Subject: **L.E. CARPENTER & COMPANY, WHARTON, NEW JERSEY, NJD002168748**
Response to New Jersey Department of Environmental Protection's Comments
dated February 22, 2006

This letter addresses the New Jersey Department of Environmental Protection (NJDEP) February 22, 2006 comments on the Post Remedial Monitoring Plan (PRMP) dated October 14, 2005. RMT, Inc. (RMT) prepared the PRMP and this response to comments letter on behalf of L.E. Carpenter & Company (LEC).

Total BTEX Concentrations vs. Water Levels for MW-19

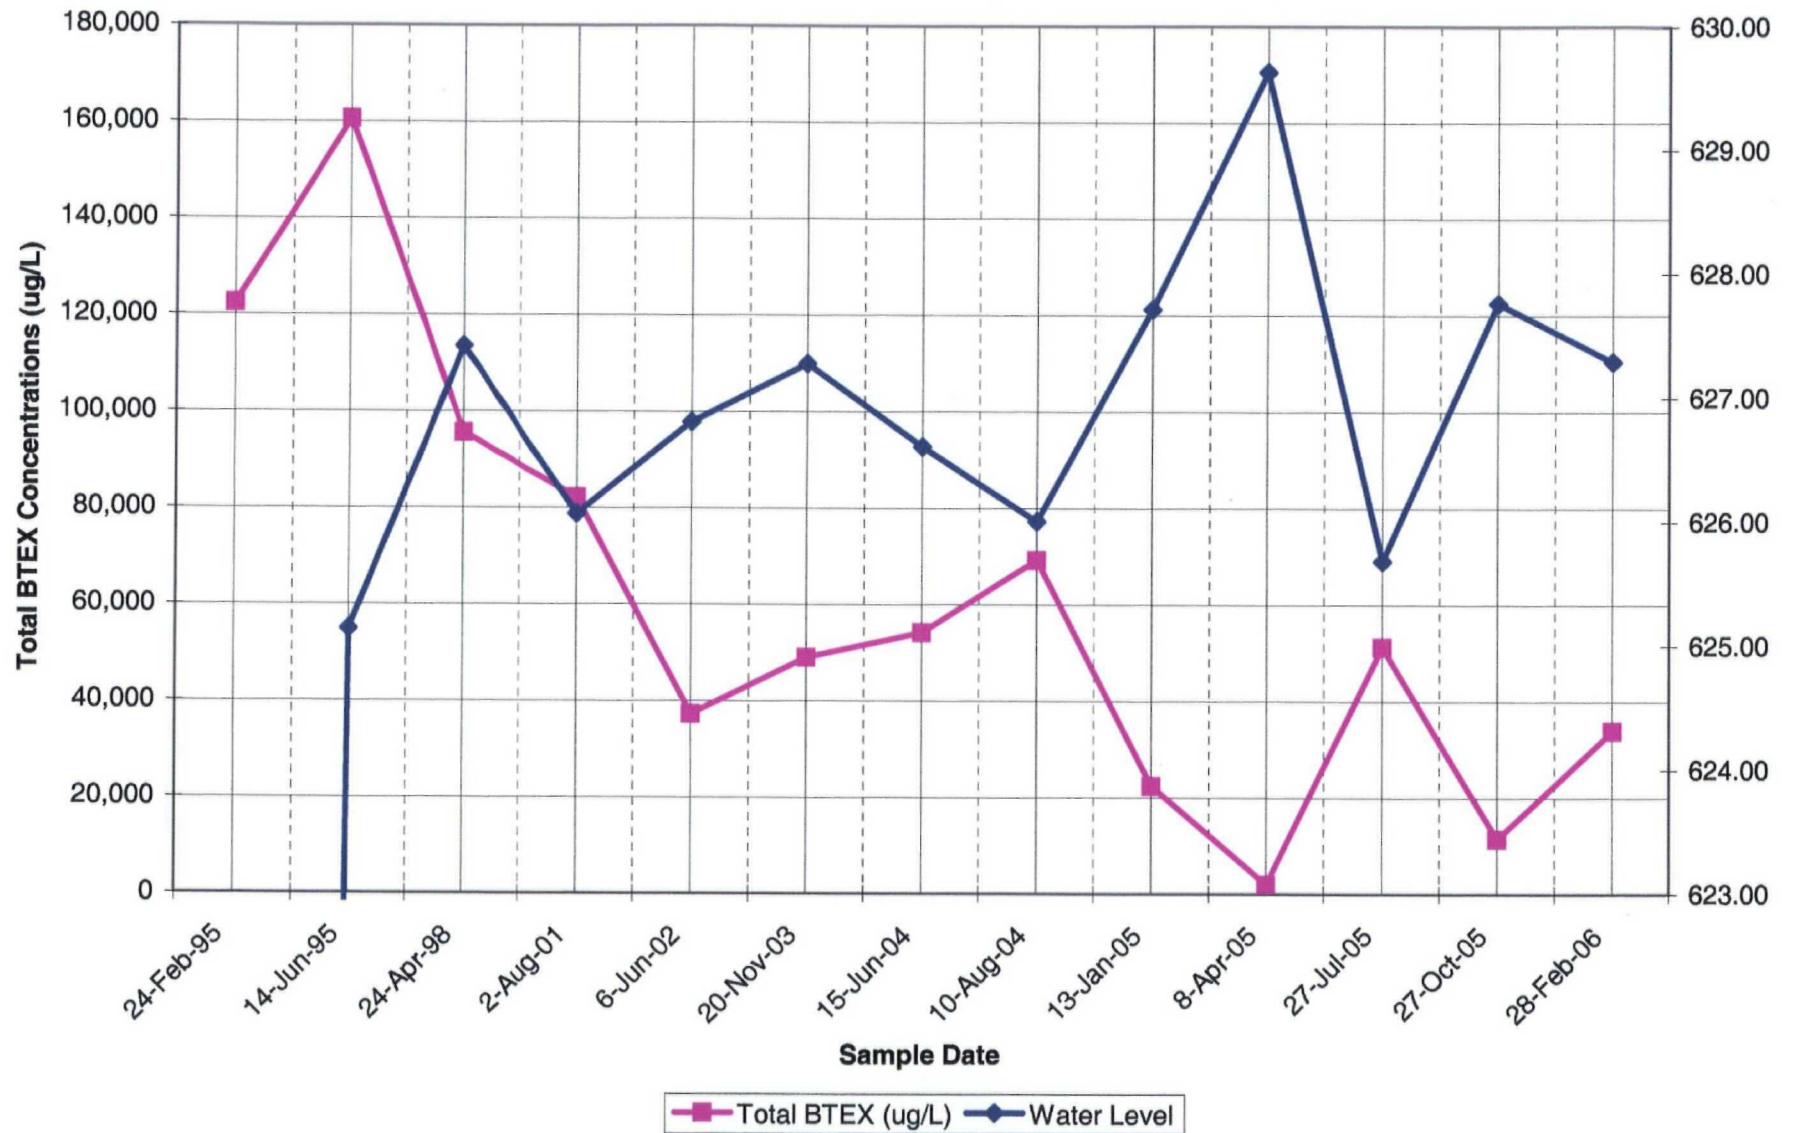
- New Jersey Department of Environmental Protection is correct in stating that groundwater contamination remains in the near vicinity of monitoring wells MW-19 and MW-19-5, as shown by the groundwater isoconcentration contours on Figure 1. However, based on current and historical data its persistence is a function of very localized residual soil contamination that appears to exist predominantly in the area between MW-19 and MW-19-5. Residual soil contamination in this area is evidenced by data contained in the 1995 and 1996 Roy F. Weston quarterly progress reports that document historical soil removal and post excavation soil sampling activities completed in the MW-19/Hot Spot 1 area. Total BTEX trend data for MW-19 (Appendix A) along with the area of previous contaminated soil removal (Figure 1) show that MW-19 is located on the west (upgradient) edge of the area most likely to contain residual vadose zone contamination because overall concentrations have steadily declined at the MW-19 monitoring location over time (note that the downward trend is superimposed on top of concentration "spikes" caused by seasonal infiltration events and groundwater level changes). The United States Environmental Protection Agency (USEPA) comment that *"Underground Storage Tanks (USTs) in the MW-19 area were removed 15 years ago, yet significant impacts to groundwater are ongoing"* should be tempered by the downward concentration trend data for MW-19. In addition, we question the use of the term "significant" in this case because all available data continue to show that the residual contamination in groundwater does not migrate off-site, predominantly due to equilibrium conditions that likely exist as a function of natural-attenuation (see additional discussions presented in the 1Q06 report regarding natural attenuation parameters). The trend chart for MW-19-5 shows that this well is likely located within or just downgradient from residual soil contamination because there is no obvious downward trend in total BTEX concentrations at this monitoring location. Groundwater level data suggest that the upward "spikes" of total BTEX are related to seasonal infiltration events and subsequent water table fluctuations.

RMT has used oil-water interface probes in the most contaminated monitoring wells within the MW-19/Hot Spot 1 area (e.g., MW-19, MW-19-5, and MW-19-7) and has never detected product in any well. In addition, groundwater monitoring results show that all individual BTEX concentrations are lower than each parameters solubility limit (see Table 2 in the 1Q06 Monitoring Report). For example, the solubility limit for toluene is 515,000 $\mu\text{g/L}$ but the highest historical concentration ever detected in any of the MW-19 Area wells is 140,000 $\mu\text{g/L}$, which was detected both in MW-19 and MW-19-5. Currently

(Ref. the 1Q06 Monitoring Report), the highest toluene concentration is 28,000 µg/L in MW-19.
